Dear Dr Panagos,

We sincerely thank you for your valuable comments on this manuscript. We have tried our best to incorporate all your suggestions. Detailed answers to the specific questions are given in the following paragraphs.

Figure 1 (a) Modified LS factor (b) re-classified soil erosion map (c) Modified R factor

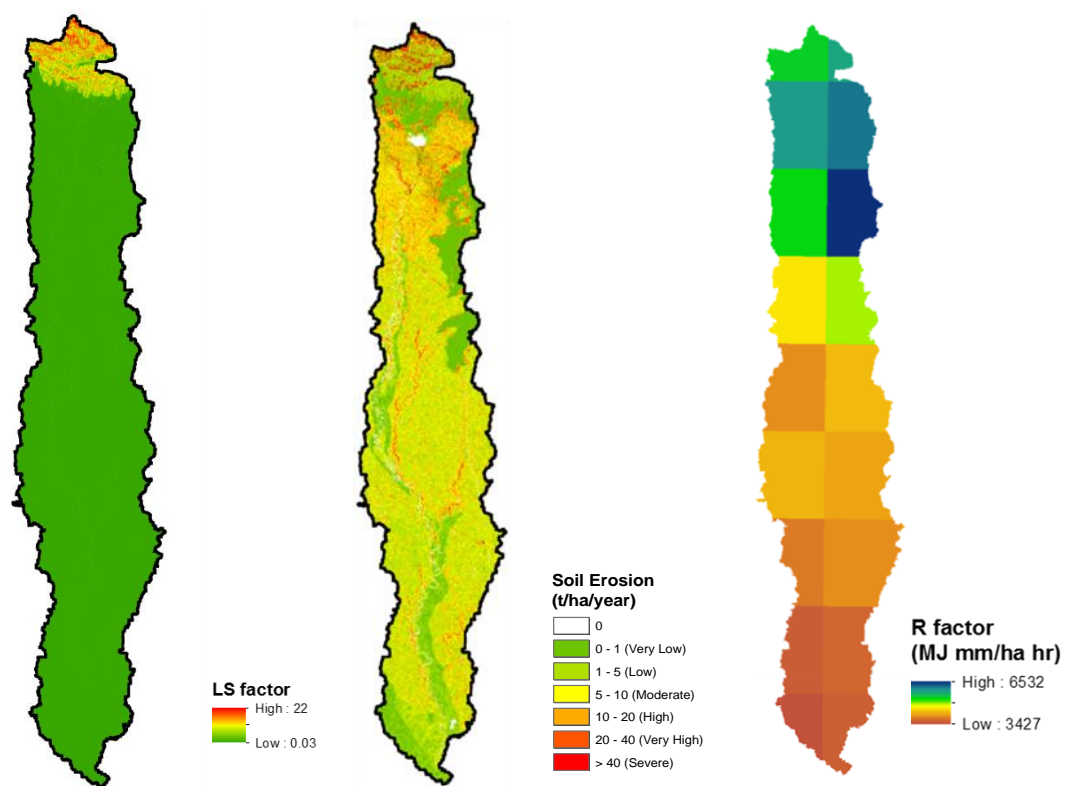
**Comment 1: In the current study, the erosivity factor (R-factor) has high uncertainties. I am not in favor of functions which estimate erosivity based on annual or monthly rainfall values (you can see the low quality results with large pixels in R-factor). Currently there is an increasing availability of high temporal resolution rainfall data which allow to estimate rainfall erosivity according to the principles of USLE/RUSLE. The recent publication and data availability of Global Rainfall Erosivity has demonstrated this and there are about 250 stations with measured R-factor in India.**

**Comment 3: In the topographic factor, authors do not discuss the pixel size issue. There much higher uncertainty when LS-factor is calculated with pixels of 90m resolution compared too much higher resolution of 25m (all this has been discussed in European application of LS-factor). Moreover, I see values of LS-factor = 2465 .This is impossible for soil coverages.**

**Comment 6: (a) The first concluding remark is not valid. this is obvious! (b) The soil erosion map could have at least 6-7 classes to show a clear distinction between low erosion , low medium , medium, high , severe, etc (with colours from Green to Red). (c) Tables should be self-explained. I don't agree with the current structure presenting the equations in the table and having the factors and annotations in separate page. It is not easy for readers.**

In this study, we selected equation proposed by Babu et al. (1978) that was developed using the rainfall data from various meteorological stations in India (Eq. a in Table 2 in the manuscript). This equation is based on the linear regression between annual average rainfall amounts and R factor. Originally, this equation was proposed to estimate R factor in meter tonnes cm / ha hr unit which needs a multiplication factor of '9.8' to convert into MJ mm/ ha hr unit (Foster et al., 1981). We had missed this factor in our estimate. After revision, we have incorporated the updated value of R factor and revised the subsequent results. Revised R factor are given in Table 1 and shown in Figure 1(c).

Yes, LS factor cannot be so high. It was a plotting error which has been corrected. Furhter, we have improved the value of slope length exponent ( $m$ ). In the previous version, the exponent is estaimted assuming rill to interrill ratio ( $\beta$ ) as 0.67. In the revised version,  $\beta$  is estaimted based on basin median slope (Morgan, 2016; McCool et al., 1997), which changed  $m$  from 0.40 to 0.14. The resulting LS factor is shown in Fig 1(a) below and its range is given in Table 1.

- a) The point is not a concluding remark, but it summarises the work done. We will remove this point from the revised manuscript.
- b) Figure 1(b) in this response shows the soil erosion map with six classes (increased from four in the original manuscript). We hope that the new figure distinguishes different soil erosion areas.
- c) Thanks for the suggestion. In the revised manuscript, symbols will be explained along with the equations in which they are used.
